SUBJECT: Final Environmental Assessment (FEA)/Finding of No Significant Impact (FONSI) for
Holland Single Family Residence (SFR) in the Conservation District at TMK parcel [1]
2-5-15:24, Honolulu, Oahu

NOTICE OF ACCEPTANCE AND ENVIRONMENTAL DETERMINATION
Conservation District Use Application (CDUA) File No. OA-3113
(BOARD Permit)

This acknowledges the receipt and acceptance for processing of your CDUA for the proposed Holland Single Family Residence: Site and Dwelling Improvements, TMK: (1) 2-5-015: 024, Honolulu, Oahu.

PROPOSED SITE PLAN

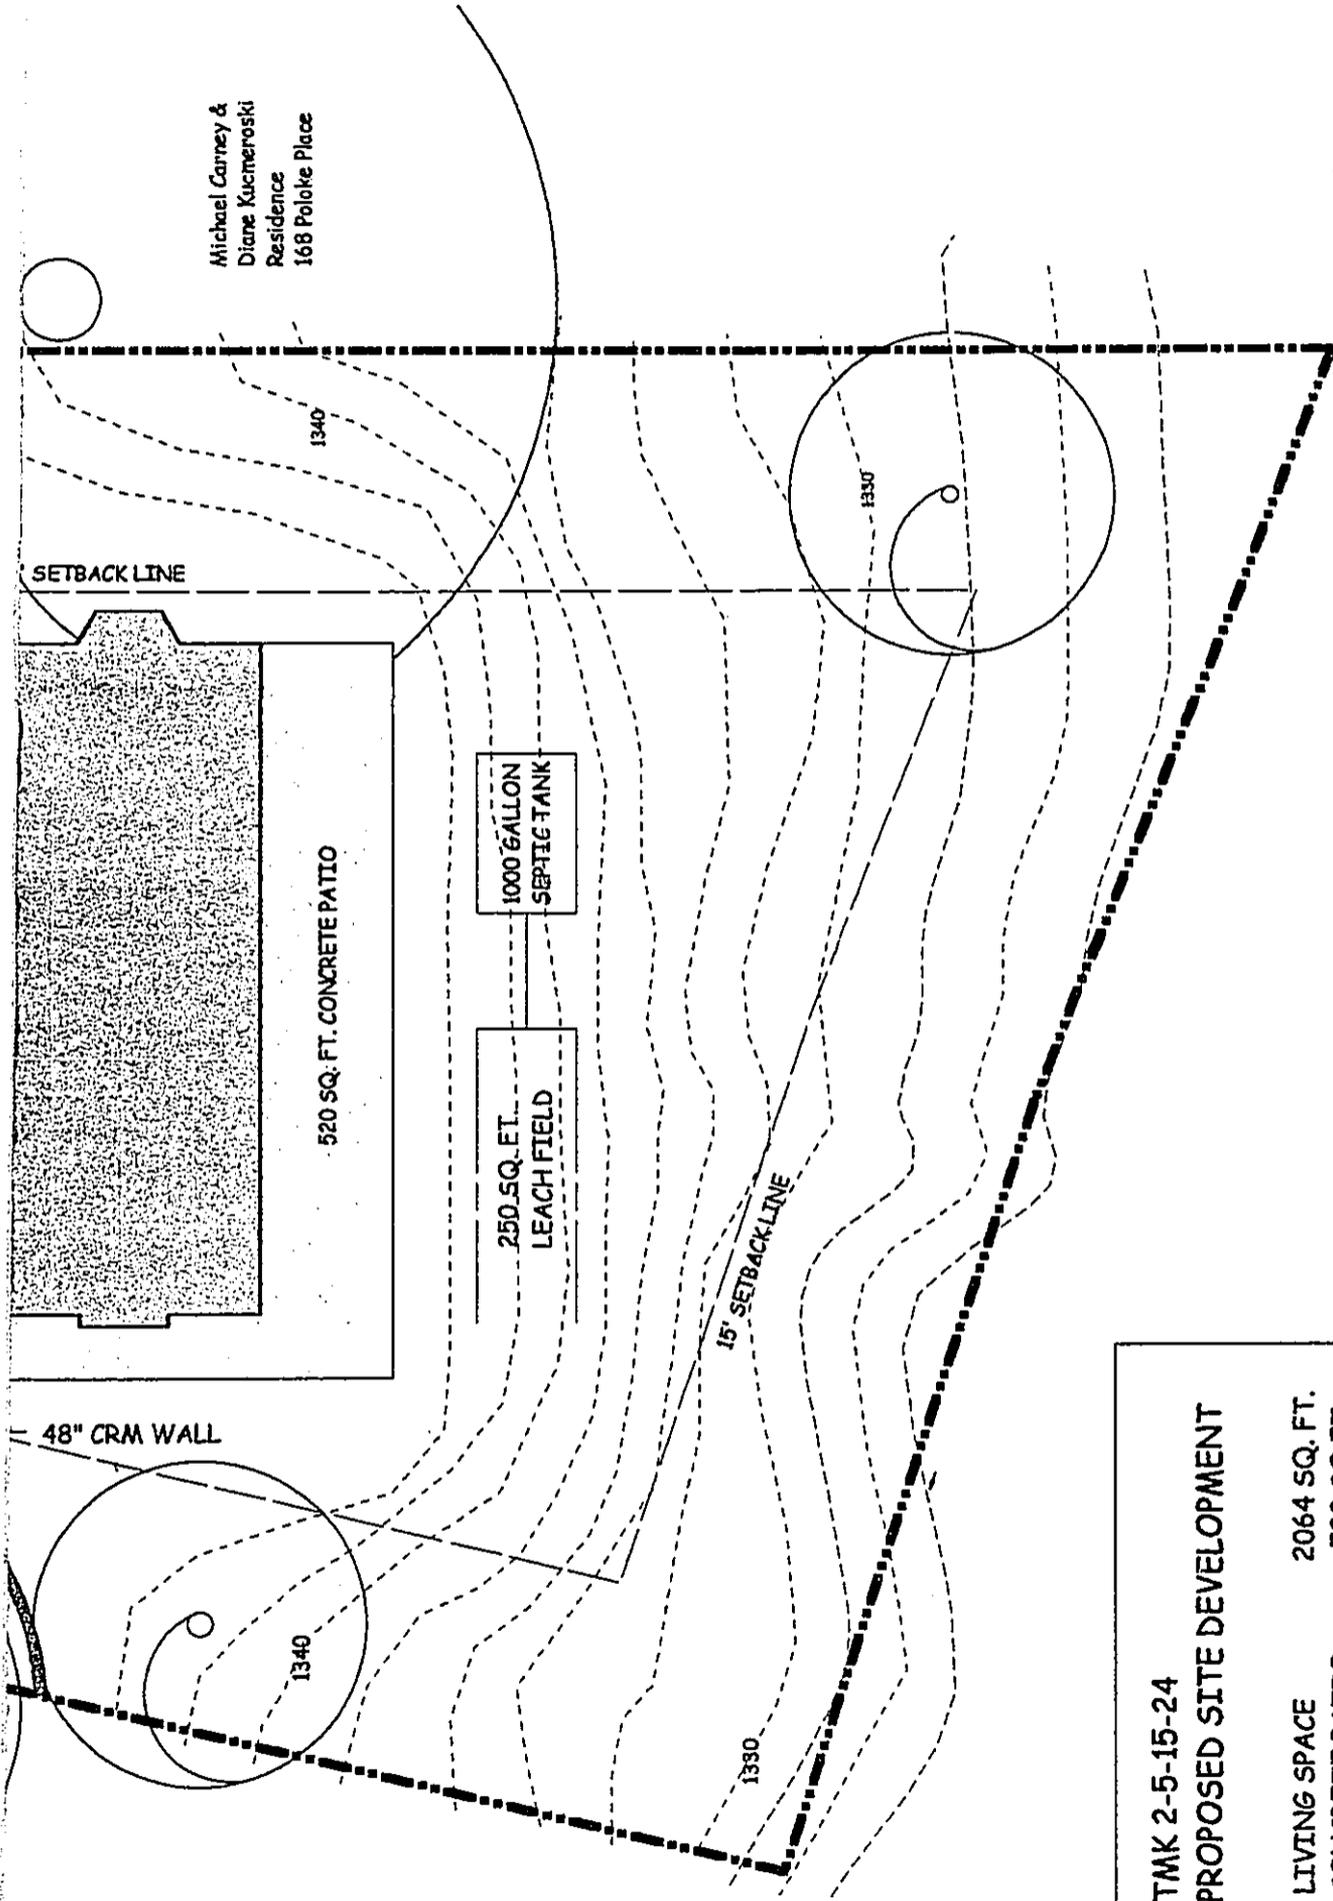
Upon acceptance of your application, staff discussed with you the necessity of incorporating the Conservation District height limitation in your plans, which were to be submitted with the final Environmental Assessment. We realize the City & County of Honolulu, Department of Planning & Permitting uses a natural grade oriented height regime. Unfortunately, the State does not. At your request, staff notifies you in writing of the need to adhere to Chapter 13-5, Hawaii Administrative Rules, Exhibit 4, Single-Family Residential Standards:
